**M E M O R A N D U M**

**SUBJECT:** Construction of two-slip boat dock, at 4506 Waterford Place  
File # SP-92-0439DS

REVIEW COMMENTS

PROJECT NAME: MALONE BOAT DOCK

LOWER LEVEL BOAT DECK & RETAINING WALL

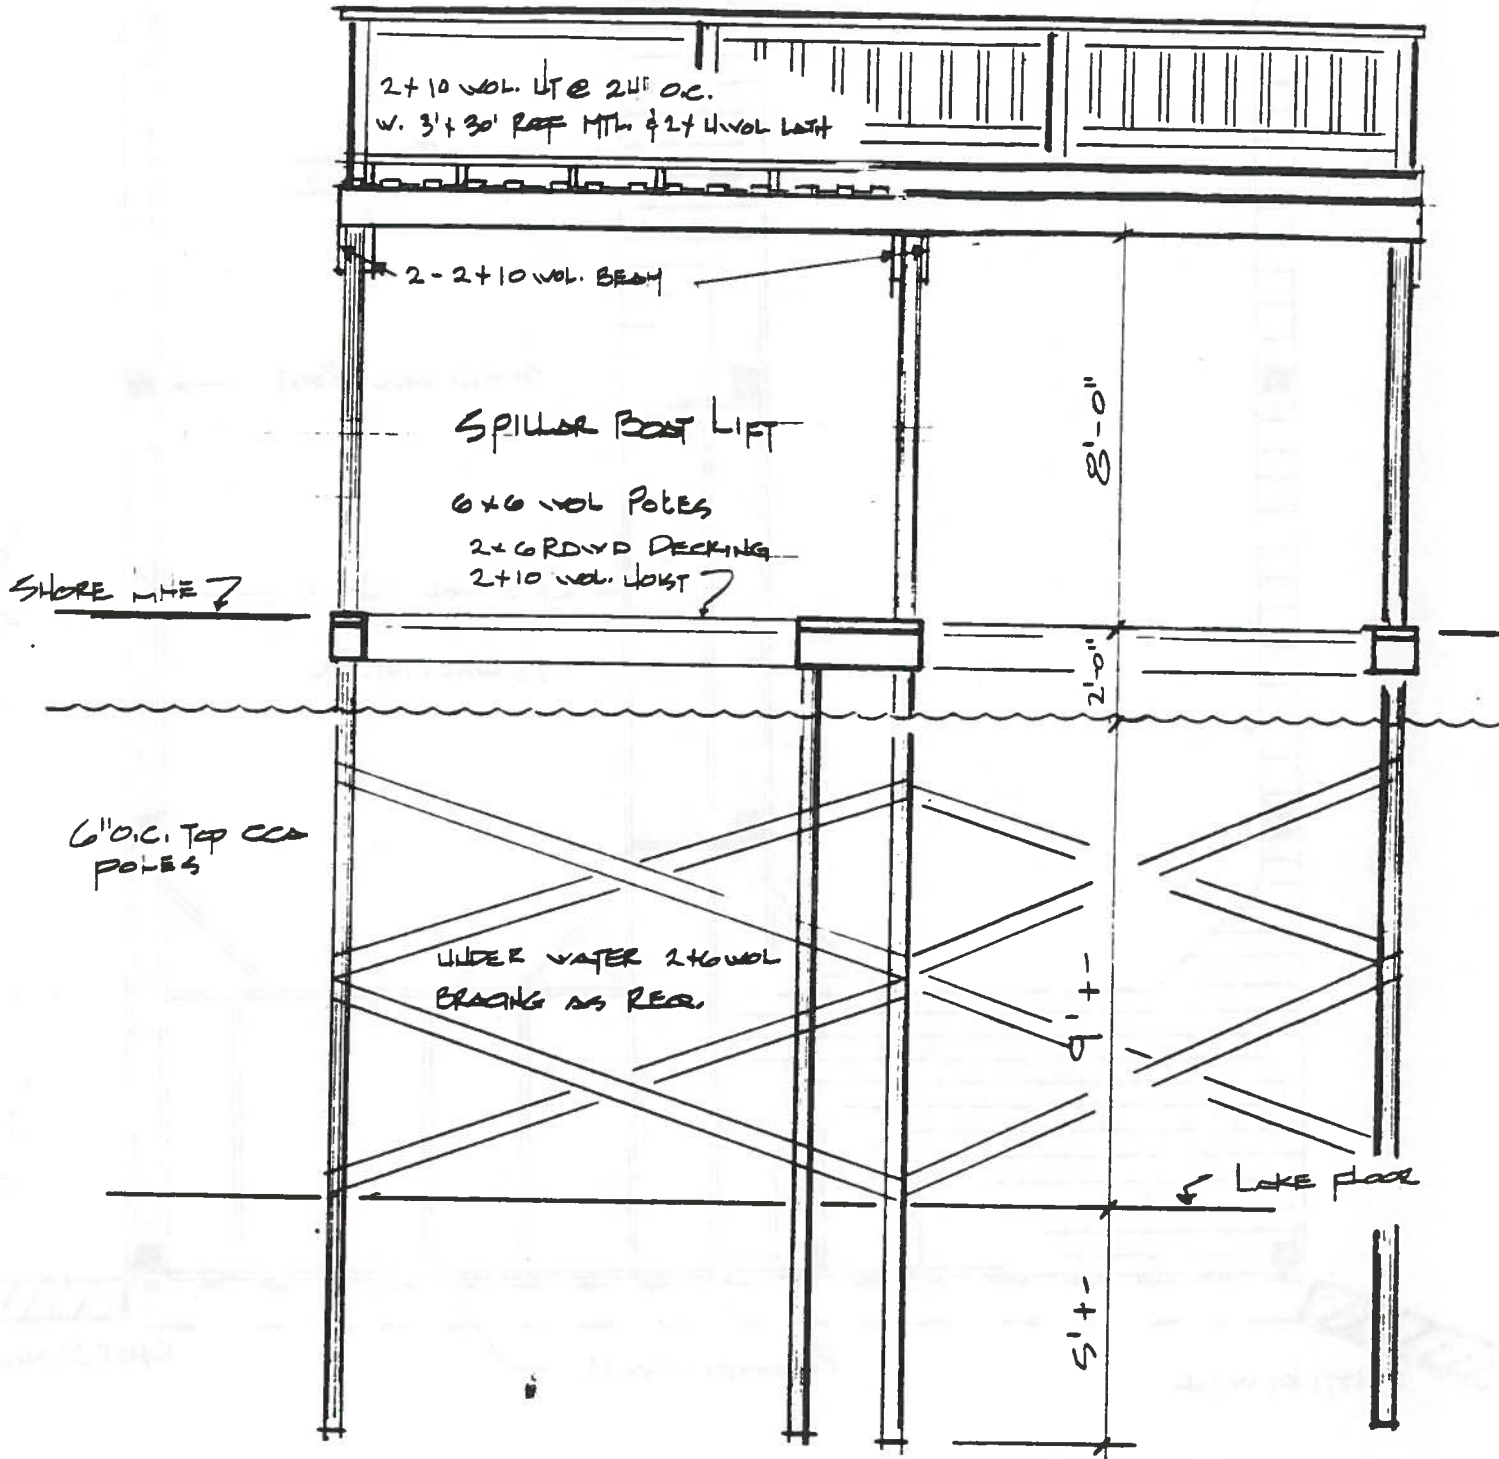
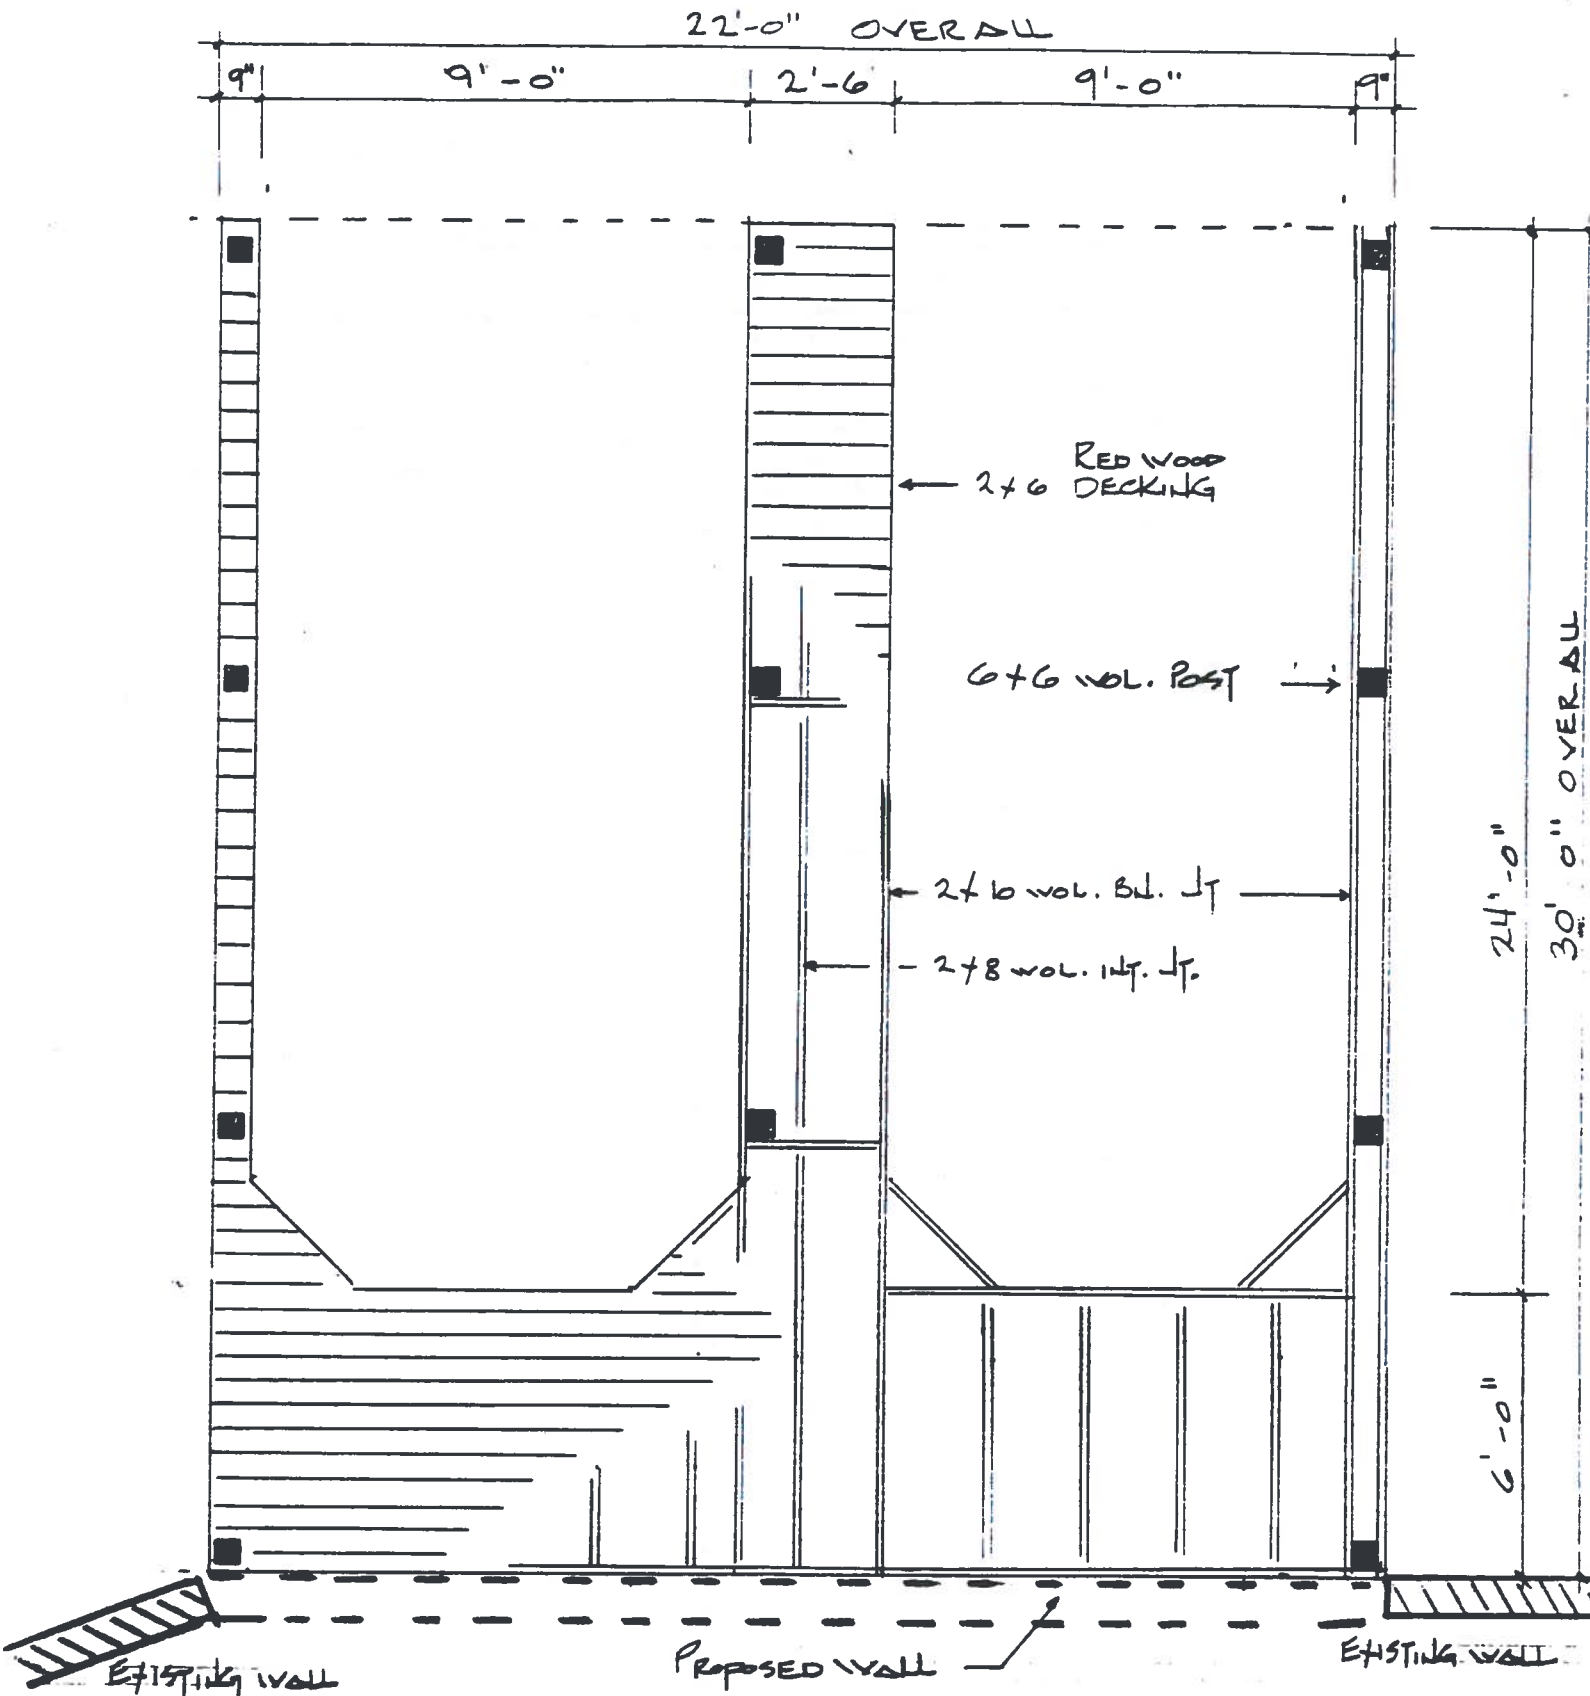
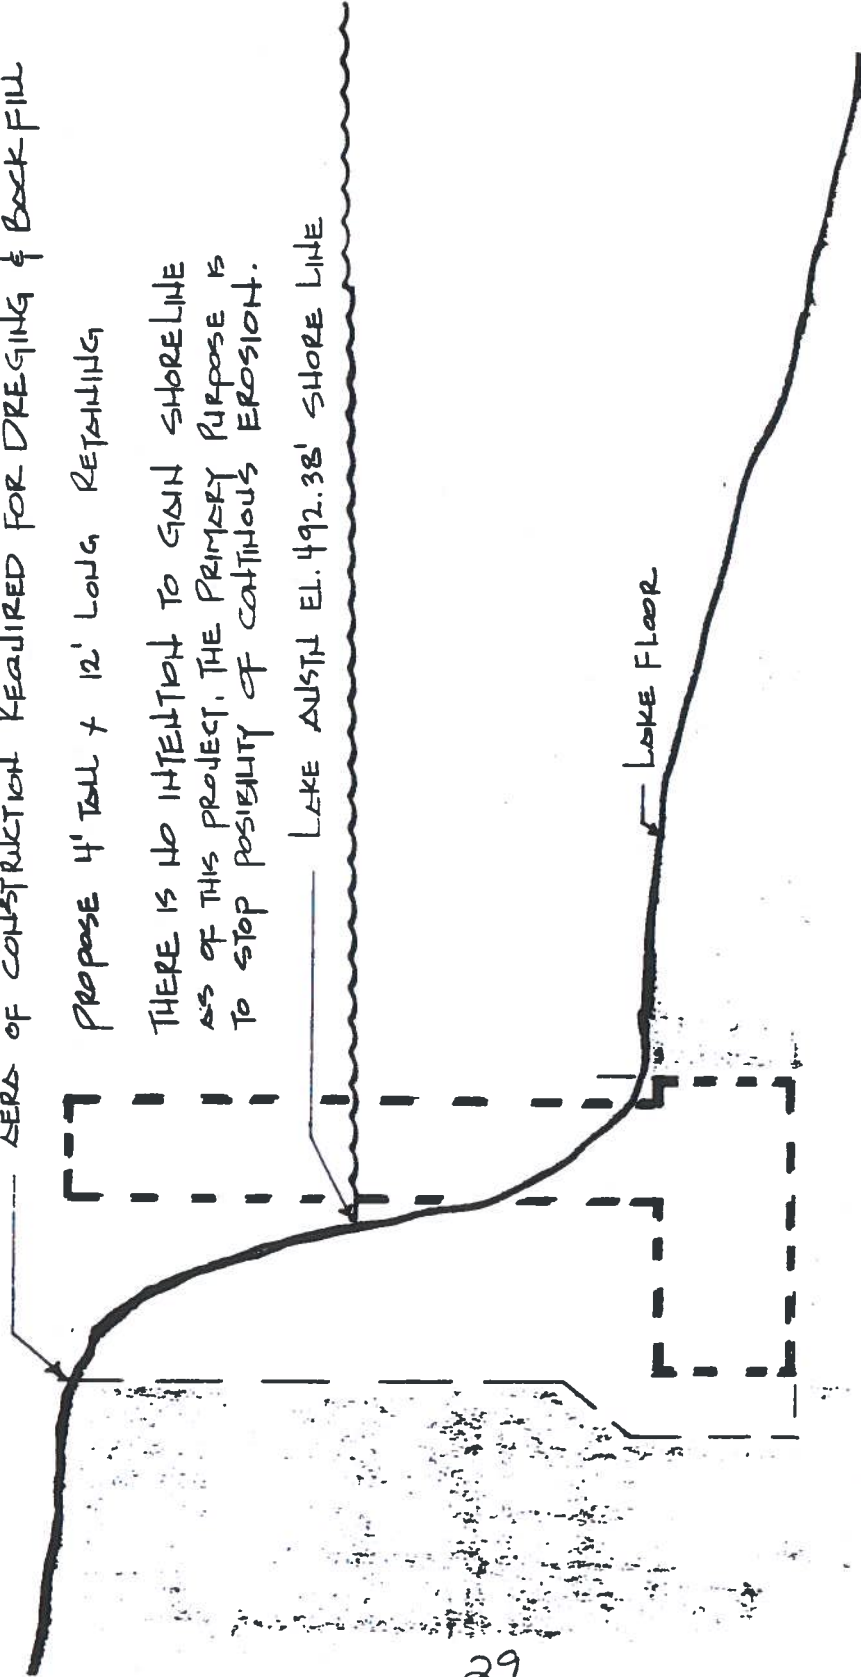
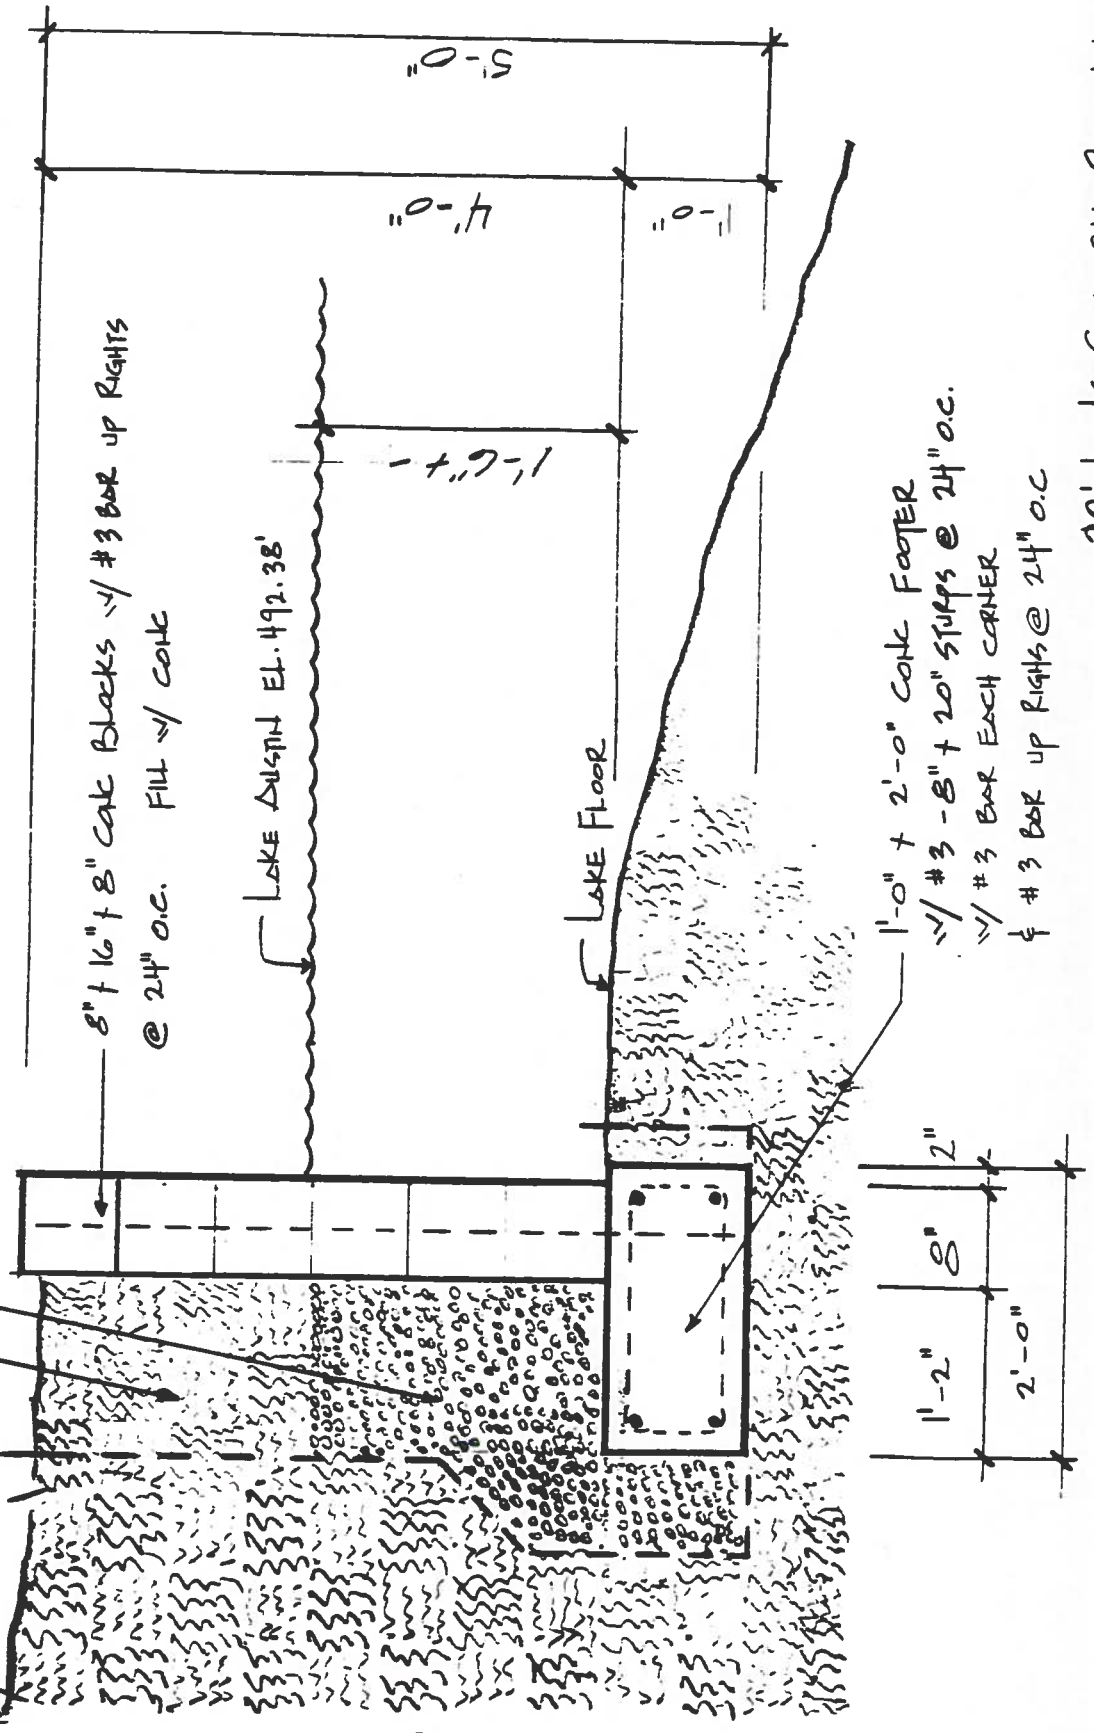
Parks and Recreation Department staff have reviewed the project and the site plans meet the requirements of Article VI, Division 4, Part E (Requirements for the Construction Of Boat Docks) of the Land Development Code (including all amendments), with the exception that no construction or navigation lighting details have been provided for the new wooden deck.

I recommend approval of the request to construct a reinforced concrete retaining wall at 5707 Leprechaun Drive, in accordance with Site Plan # SP-93-0033 subject to the following conditions:

1. Details of the construction of the proposed wooden deck and the navigation lighting, to City Code, be provided.
2. The above details be reviewed for compliance with the relevant sections of the City Code before the site plans are released for construction.
